1800 Terry

SEATTLE, WA 98101 DPD# 3022347

DOWNTOWN DESIGN REVIEW BOARD:

Design Recommendation Meeting 2 September 5, 2017

DRB 1 Response Comments Matrix

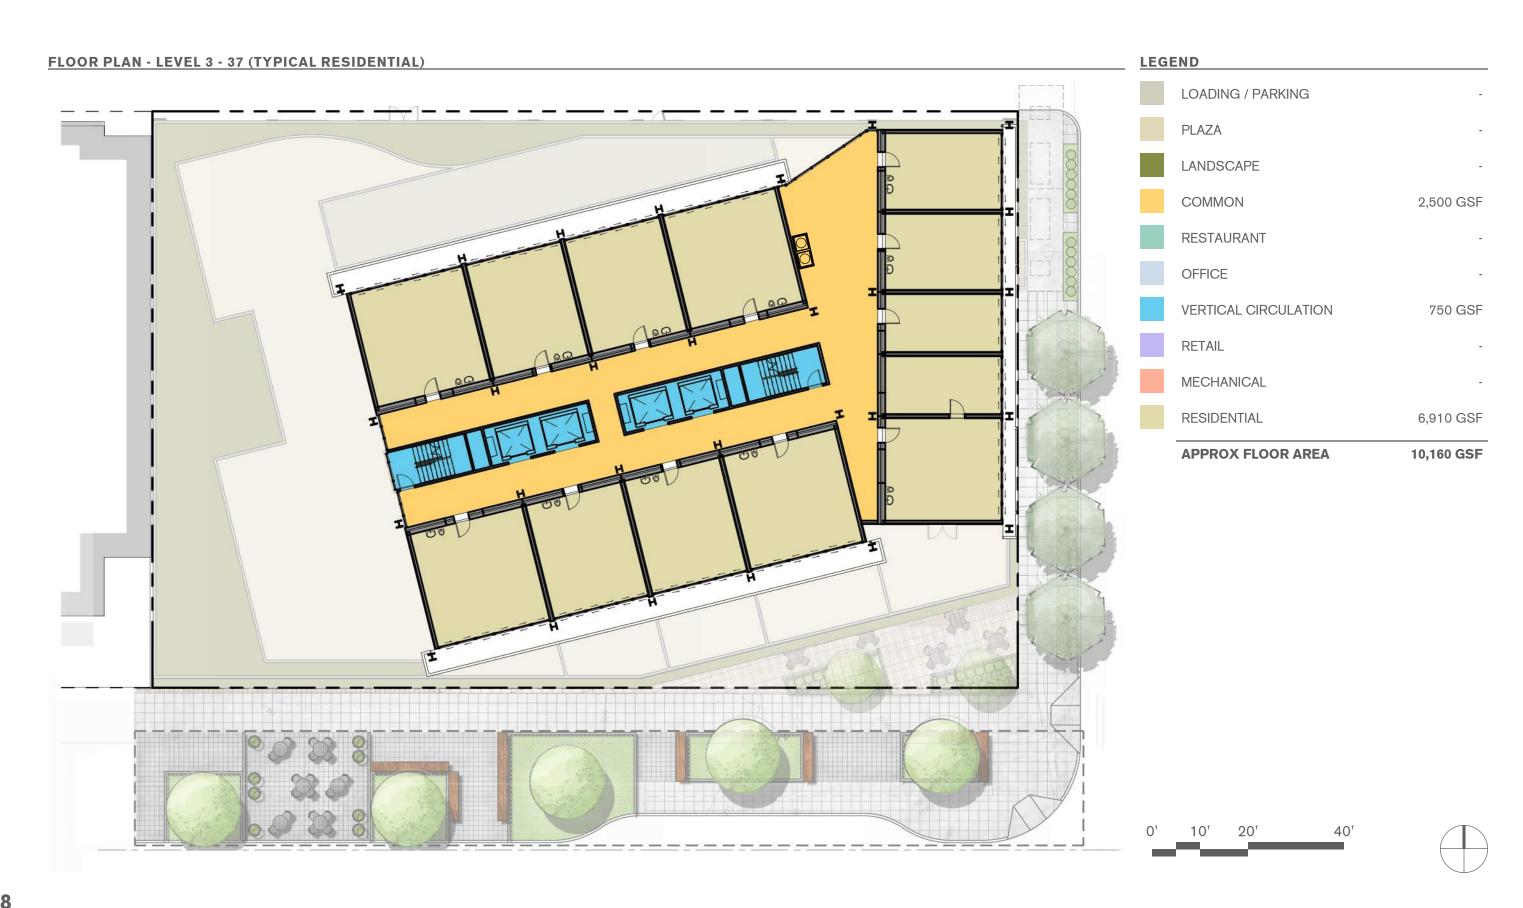
BOARD COMMENTS	OUR RESPONSE TO BOARD COMMENTS	PAGES
3	THE STREETSCAPE		
	At the Recommendation meeting the Board noted in several instances that the street level public open space needs to be larger and more accommodating to the public like a public plaza. The Board noted that street level uses need to be more fully defined with more design commitment. The Board cited Howell Street and the alley which needed more care in design development. The Terry Green Street concept is installed and should retained and enhanced by the project landscape design. The interaction of streetscape, urban plaza and building should be porous, comprehensible, comfortable, and enjoyable.	Additional architectural elements have been added to the alley facade in the form of transparent glass into the open kitchen space as well as additional pedestrian oriented lighting. (p. 44, 54, 78)	1 '
4	VEHICULAR ACCESS AND PARKING

At the Recommendation Meeting the Board directed the applicant to continue with the parking concept as presented at the meeting. They reiterated their direction to further detail the alley façade since it will be used by pedestrians and bicyclists.	The parking concept has not changed since the previous meeting. As part of the 1800 Terry proposal, the alley facade has now incorporated glass on the frontage closest to Howell St., as well as additional pedestrian oriented lighting in the alley for pedestrians and cyclists alike. (p. 54)	(p. 54)
